**MOUND PLANT
Potential Release Site Package
PRS # 306/314/406**

PRS 306/314/406

REV	DESCRIPTION	DATE
0 PUBLIC RELEASE	Available for comments.	Mar. 14, 1996
1 FINAL	Comment period expired. No comments. Recommendation page annotated.	Oct. 10, 1996
2 FINAL	Signature page changed to show correct review period.	Nov. 19, 1996

Figure 1

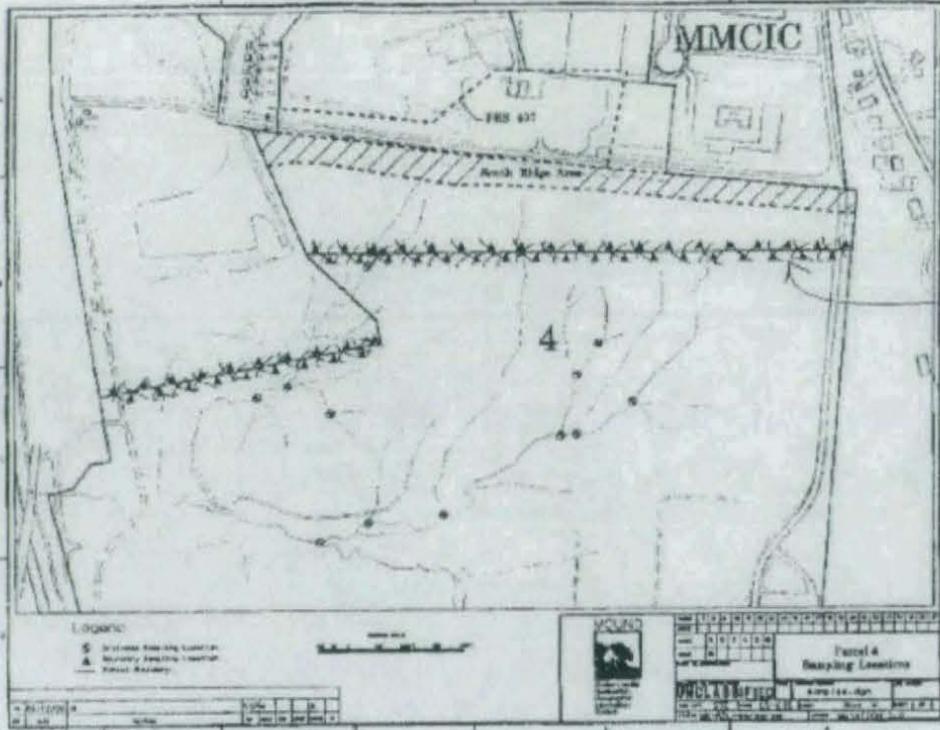
We are doing the slashbusting to clear the Parcel 4/5 boundary such that sampling to release Parcel 4 may occur. The entire extent shown may not need to be slashed but the maximum width and length were shown as worst case. Please feel free to call me if you have any other questions.

Please see the attached map which defines slashbuster activities we have planned to start next week.

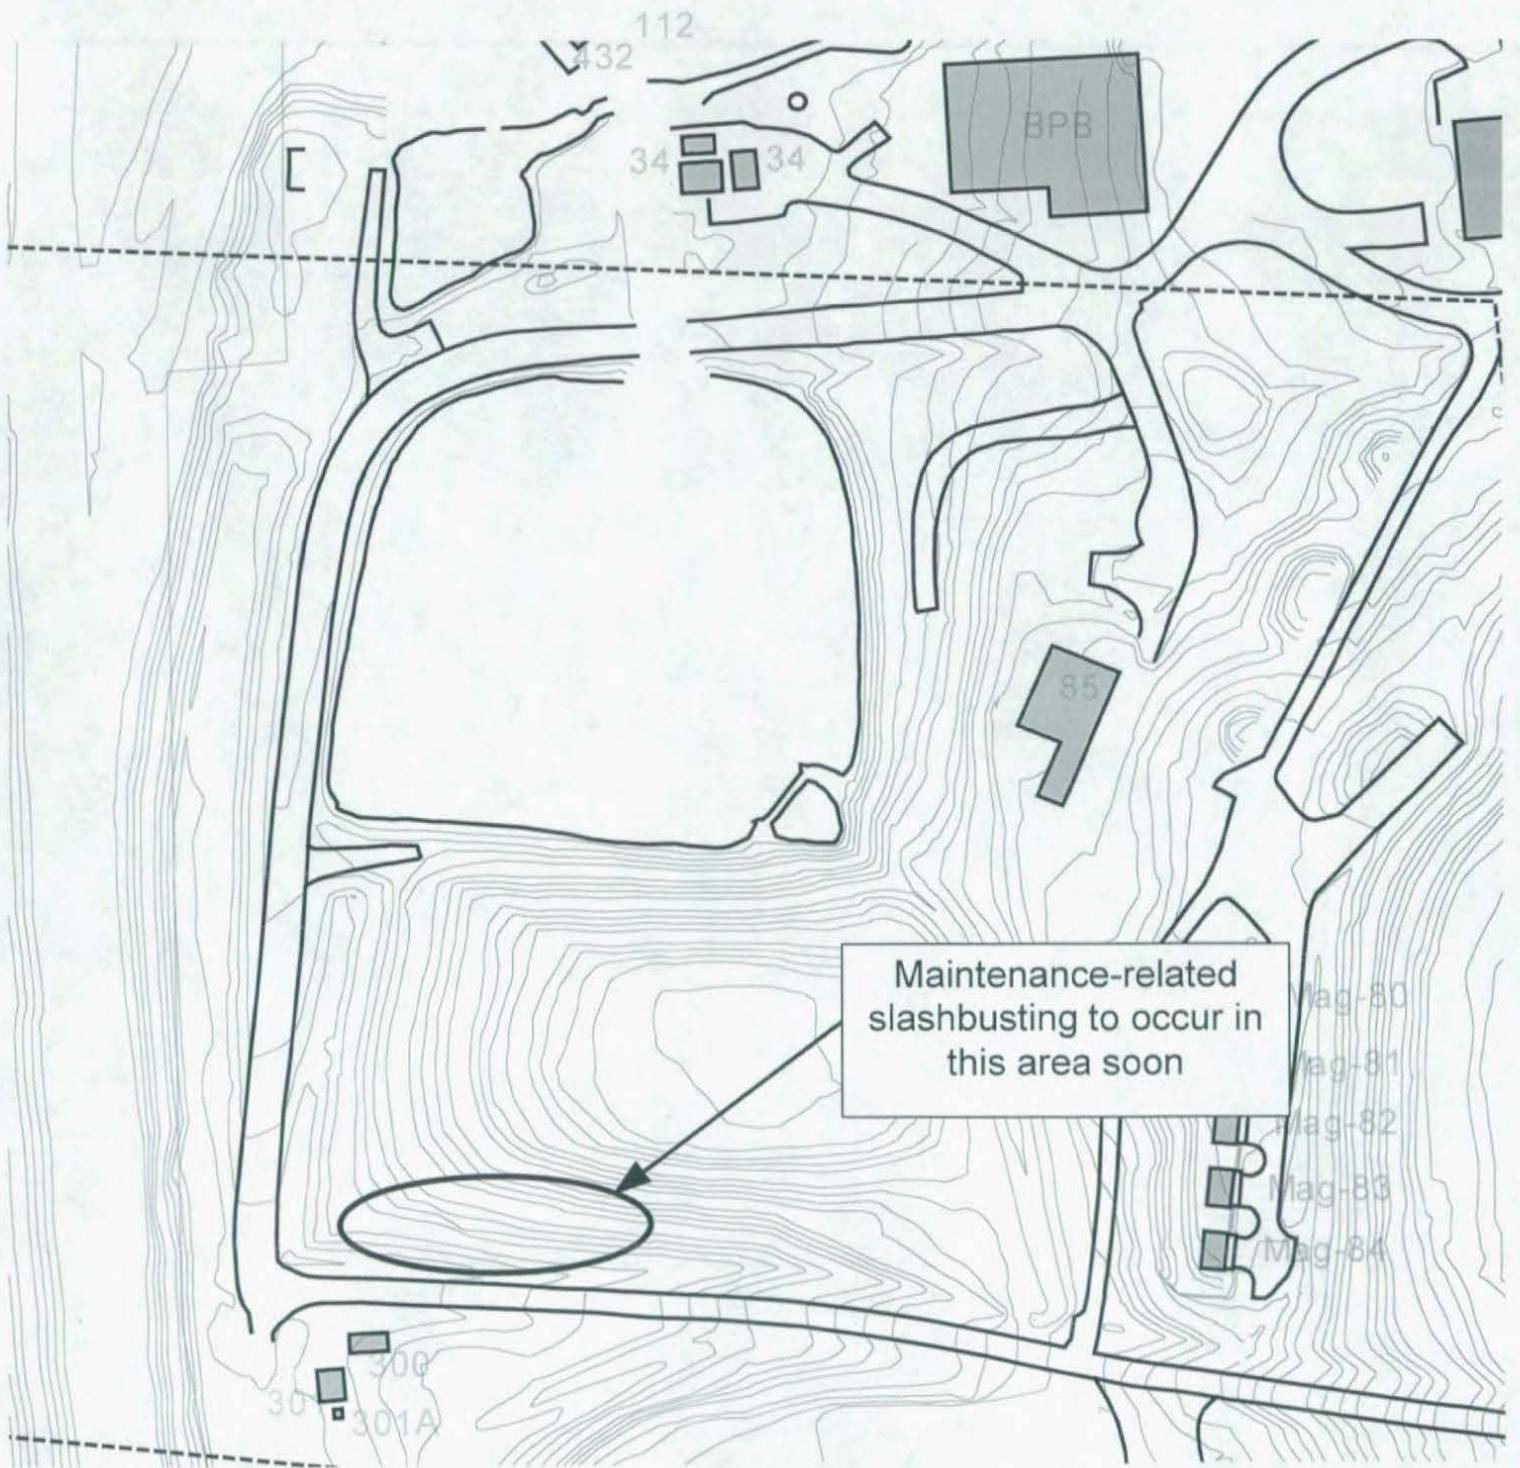
Enclosed is a figure showing the location of a planned maintenance-related slashbuster event near the overflow pond. It is related to groundwater monitoring/sampling stuff. Call or respond if you need further info etc.

I have reviewed material on above
captioned matter and have
determined no MMCIC reuse plan
impact

FIGURE 1

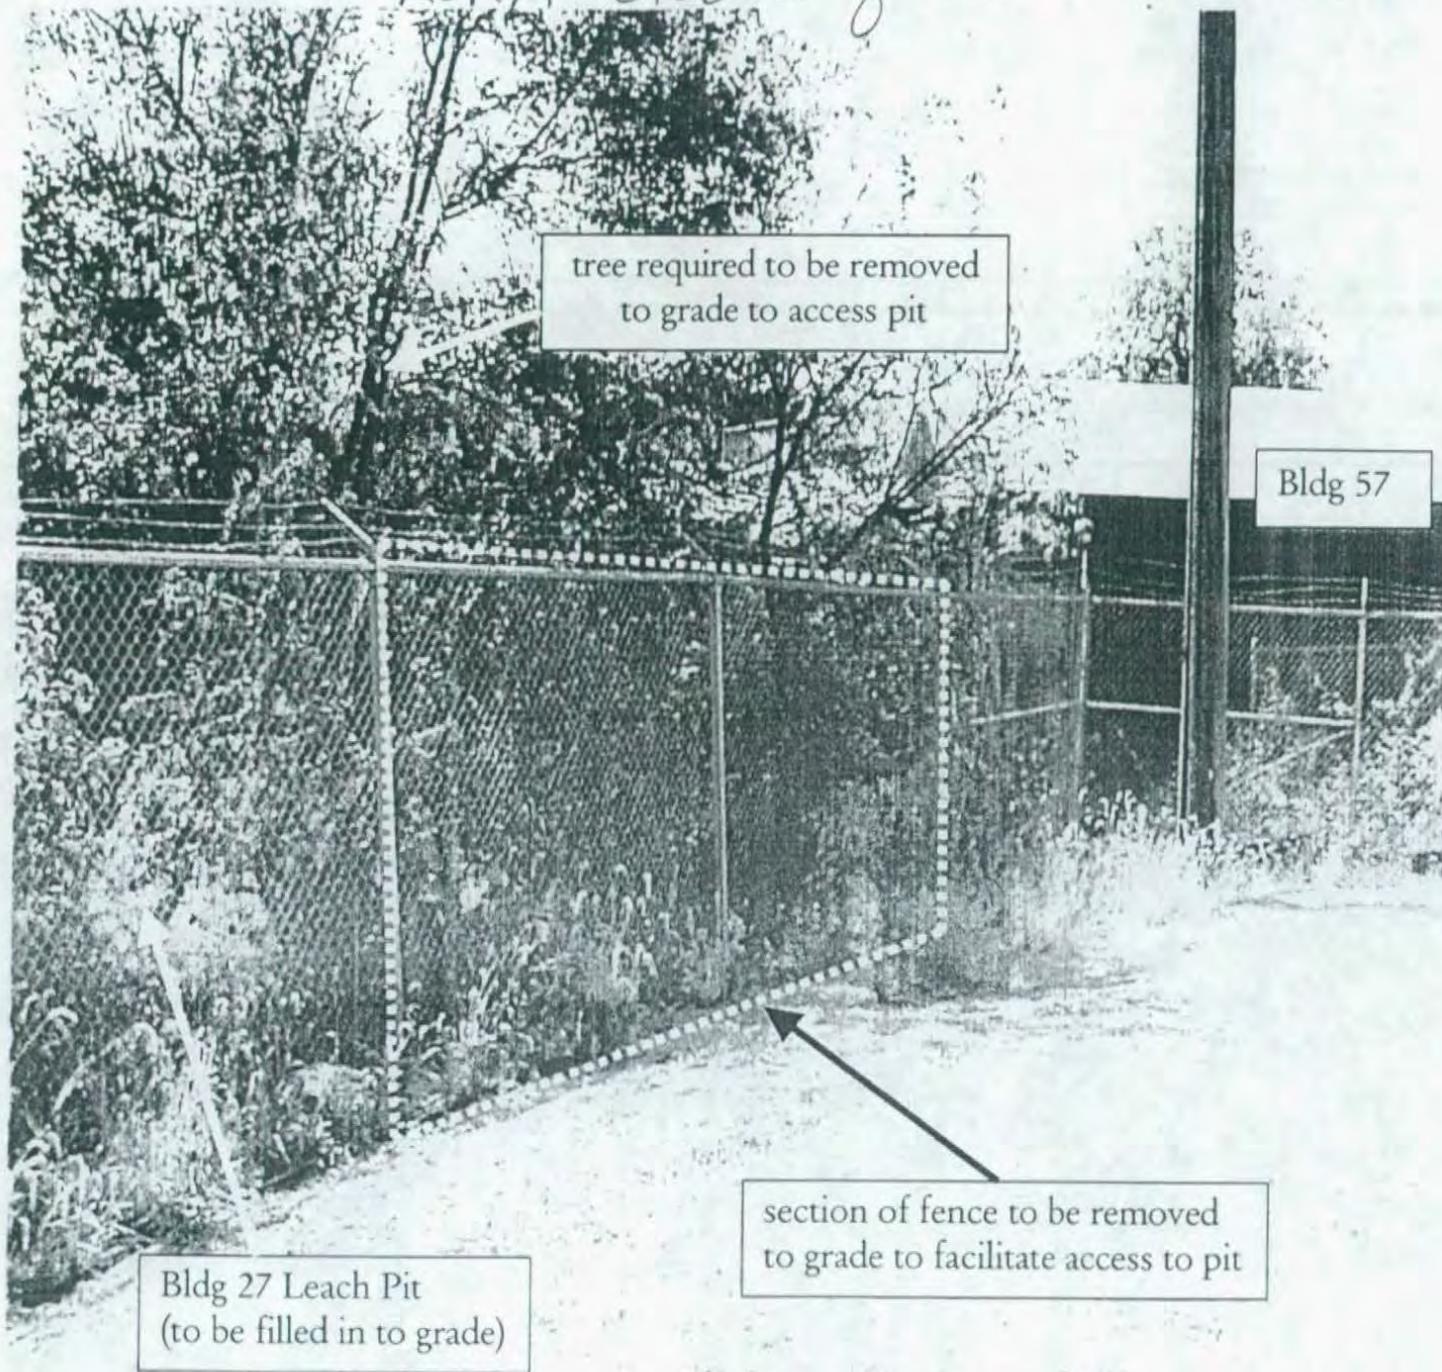
Fence removal to facilitate backfill of former leach pit associated with Building 27 was discussed and not objections were made. *see figure attached*

Fence to be removed

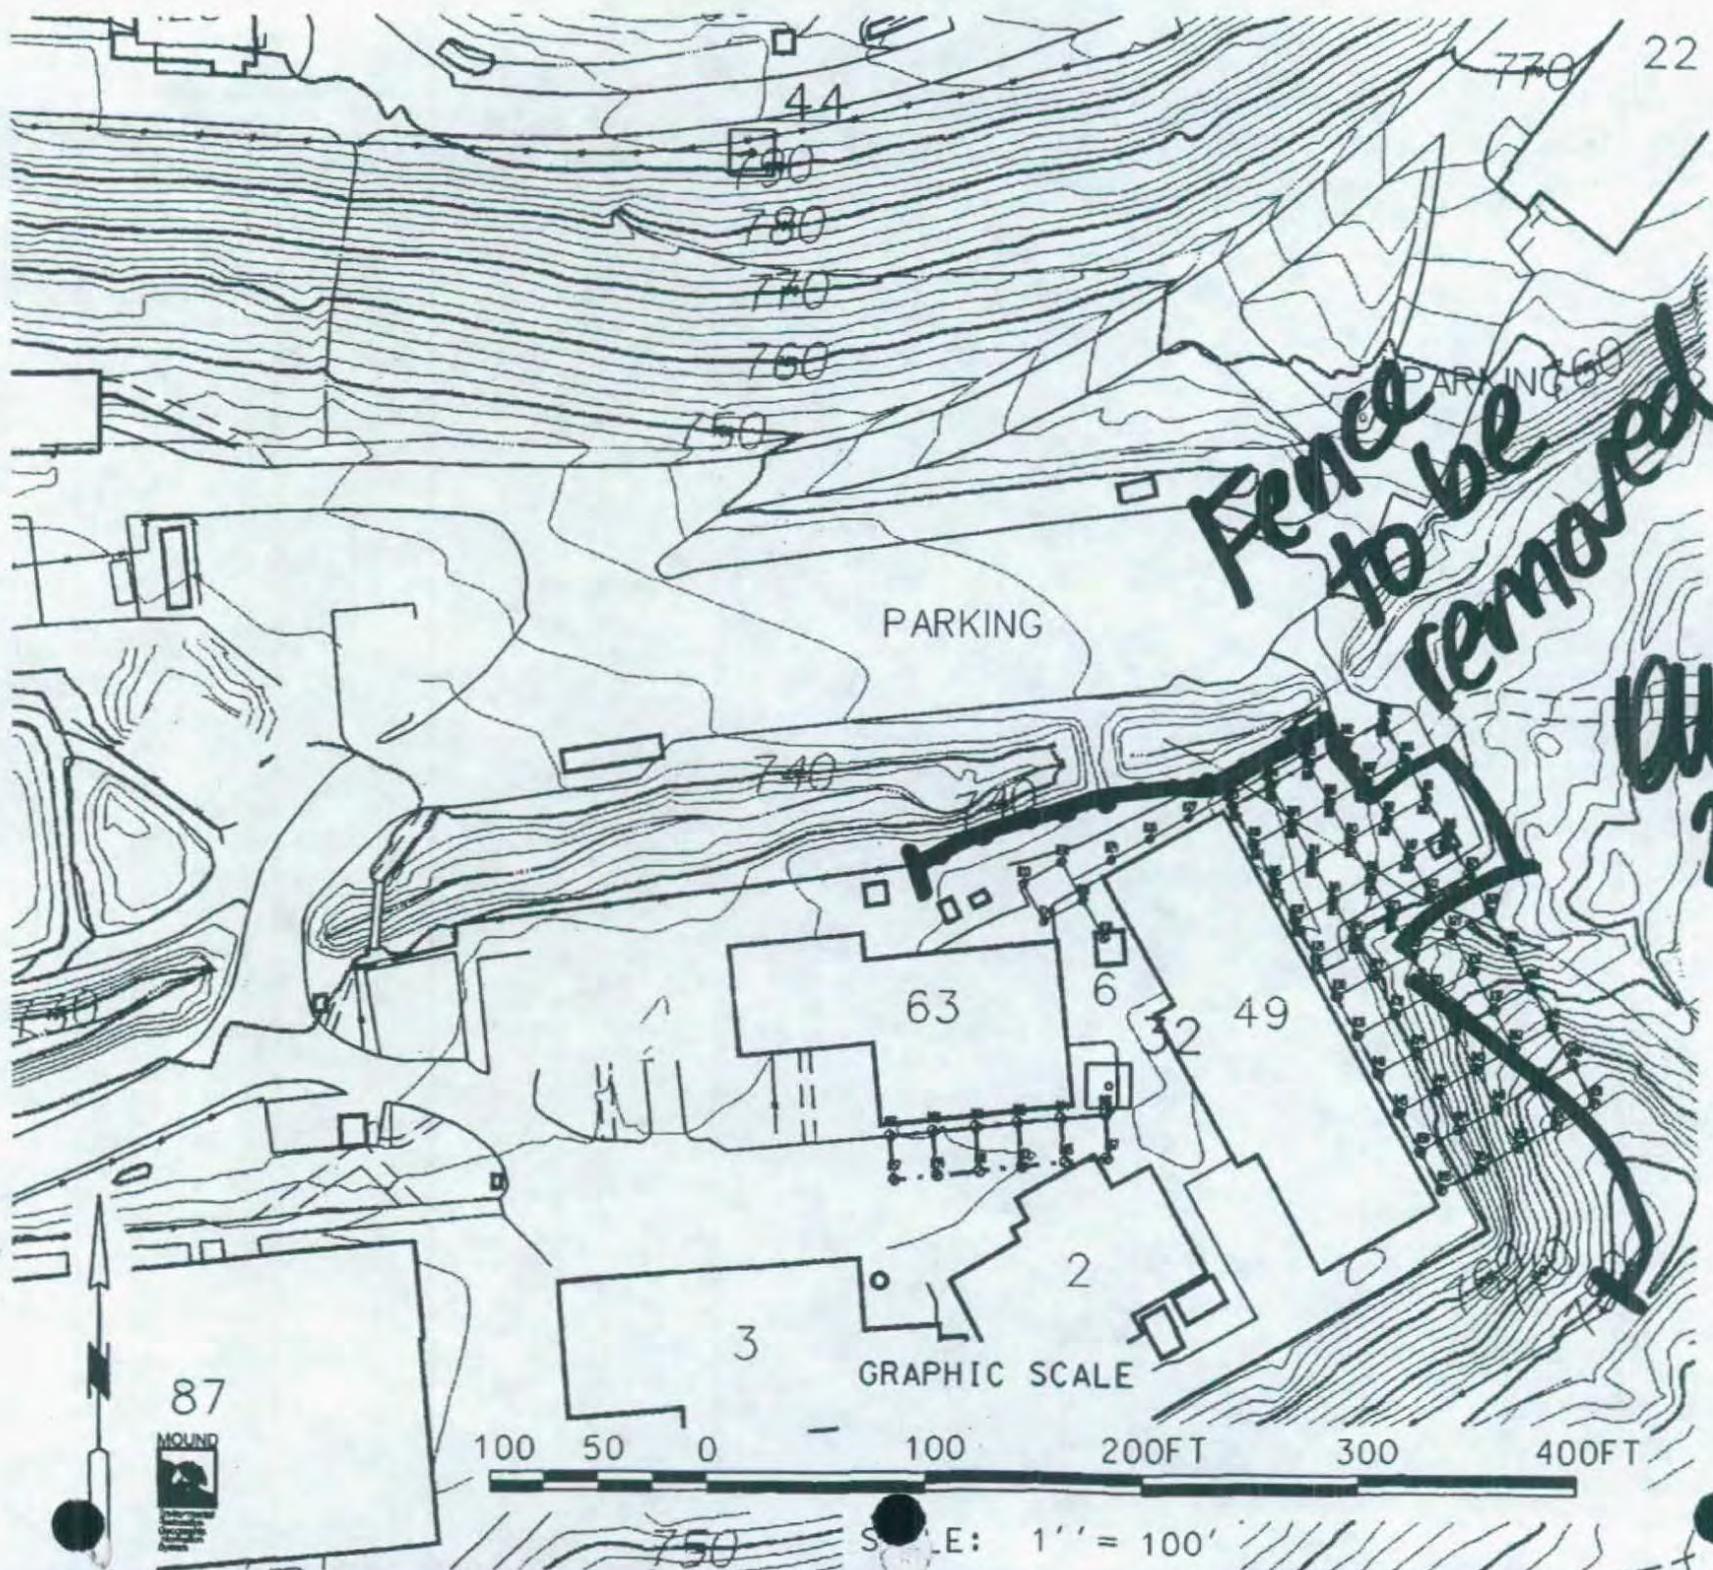
Representative removable and direct surveys were performed on the Bldg 51 fence and the PRS 72 fence at the areas indicated on the drawing you provided. All smears indicated removable levels were < 20 dpm/100 cm² alpha and < 1000 dpm/100 cm² beta.

These fences were did not have a known history of being located in a contamination area or high contamination area. There was a low possibility of them being contaminated. All surveys indicated levels below the table 2.2 values for both alpha and beta and no further surveys are required for you to remove and dispose of the fences.

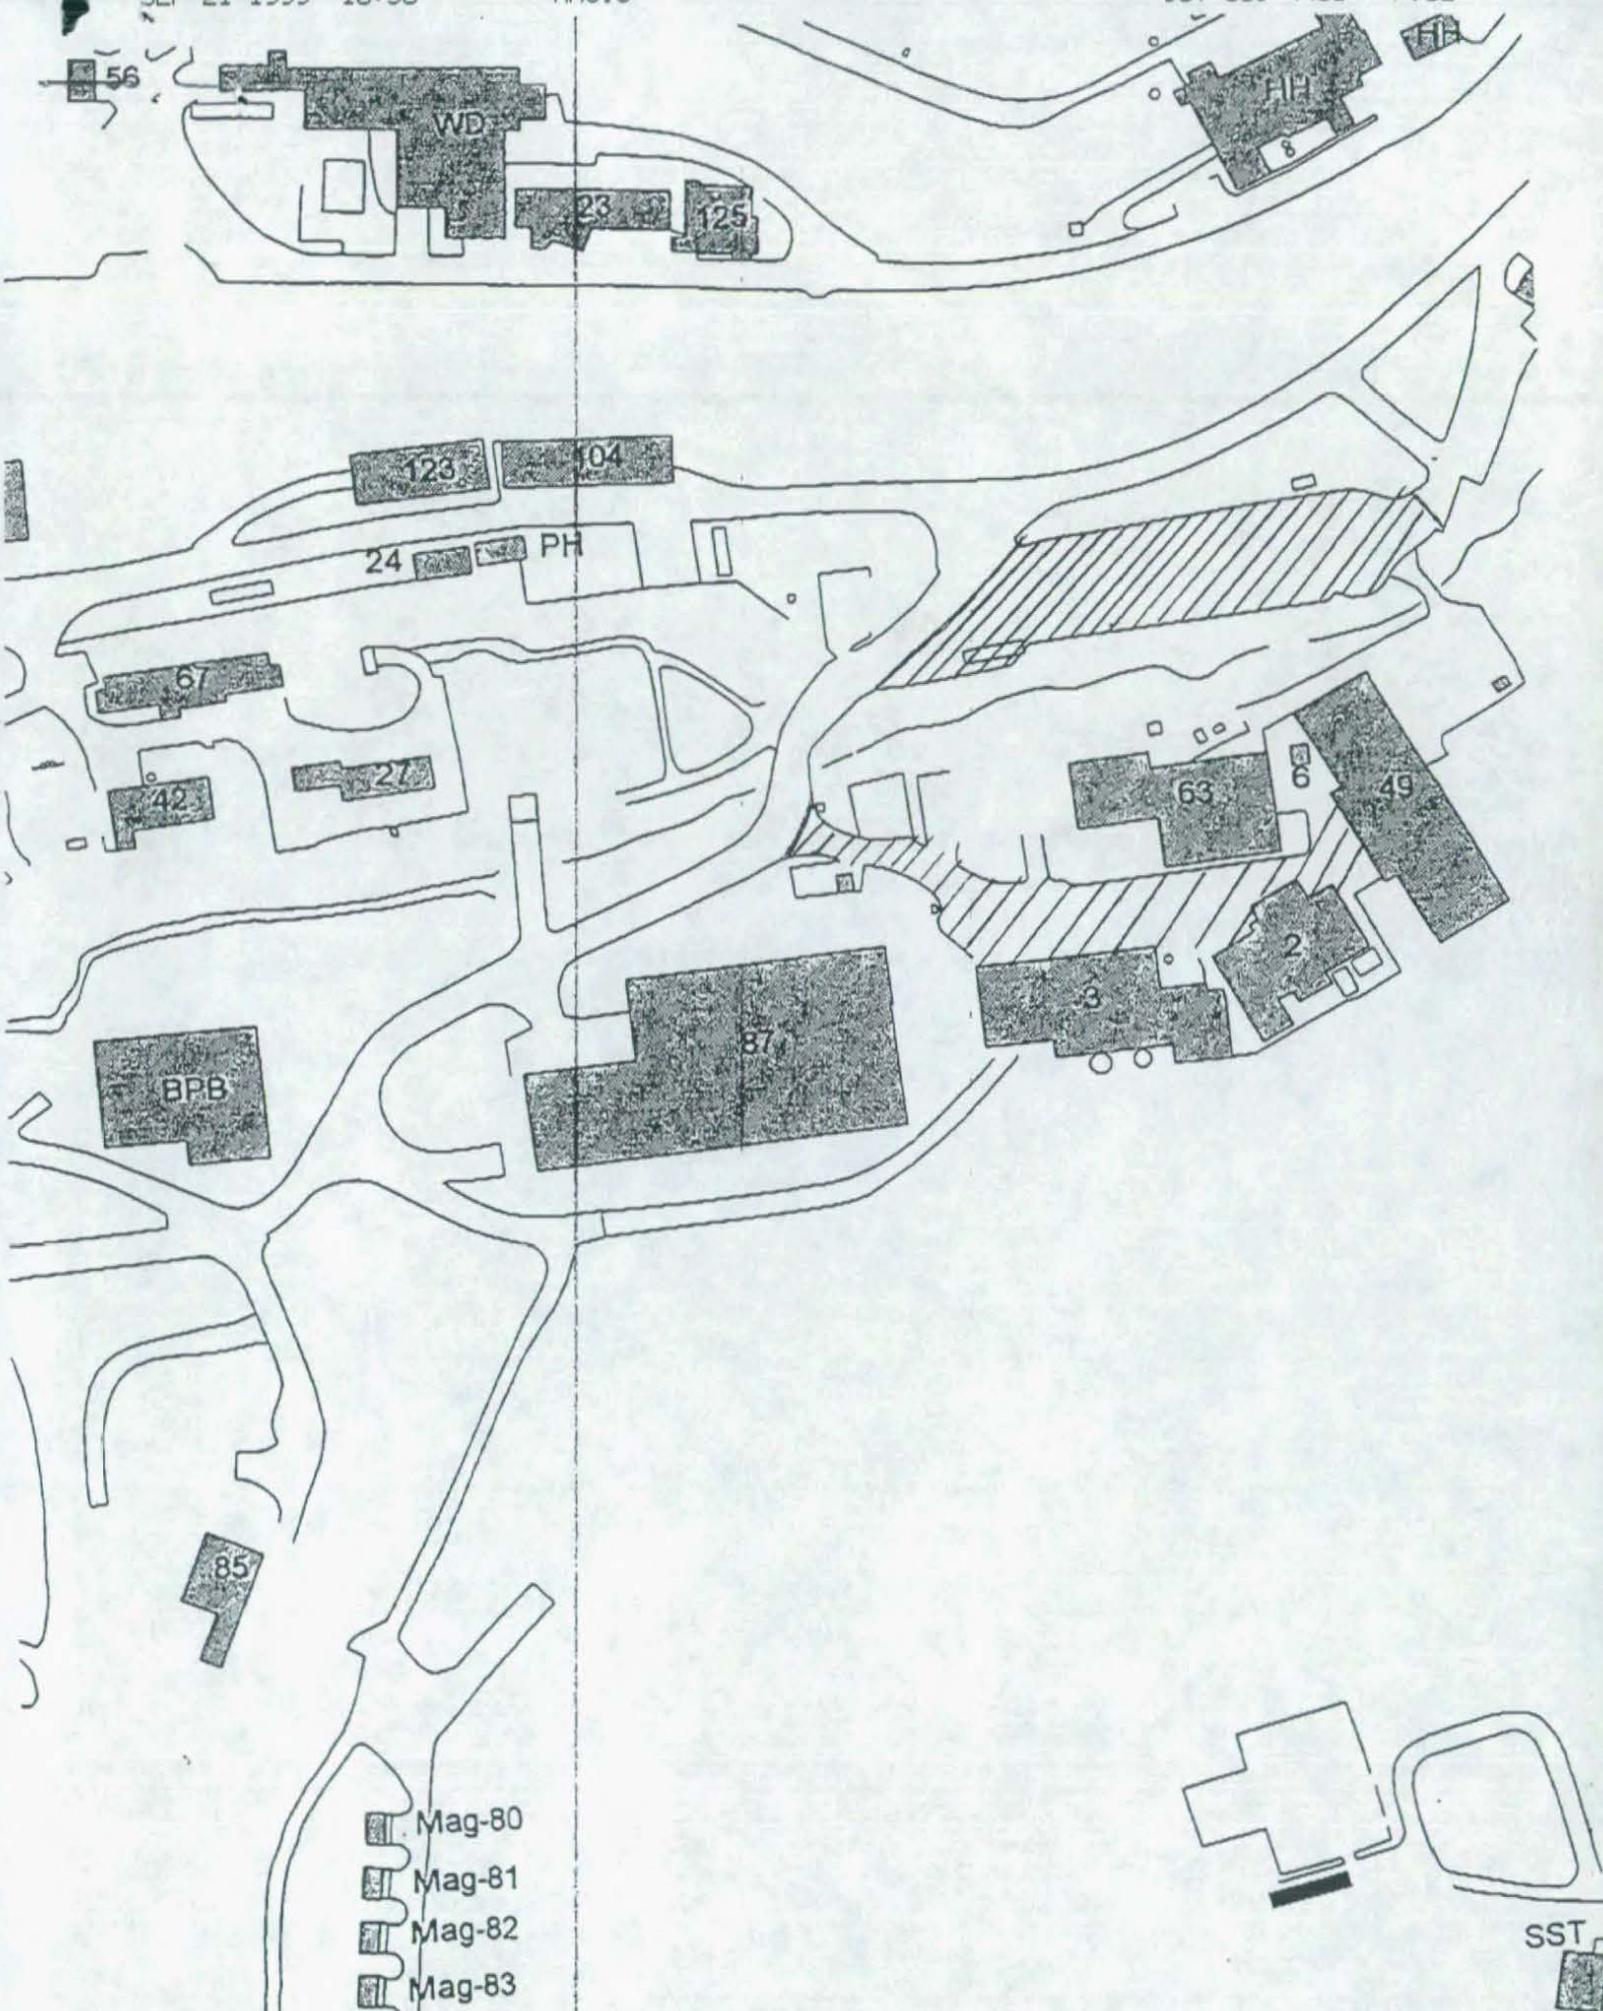
COMMENTS: Karen - Attached is a drawing showing the parking areas in Test Fire. MMCIC wants to repair, slurry seal and strip. We would like to do this before end of Oct. Let me know what you find out relative to trailers and PMS 72 scheduling.
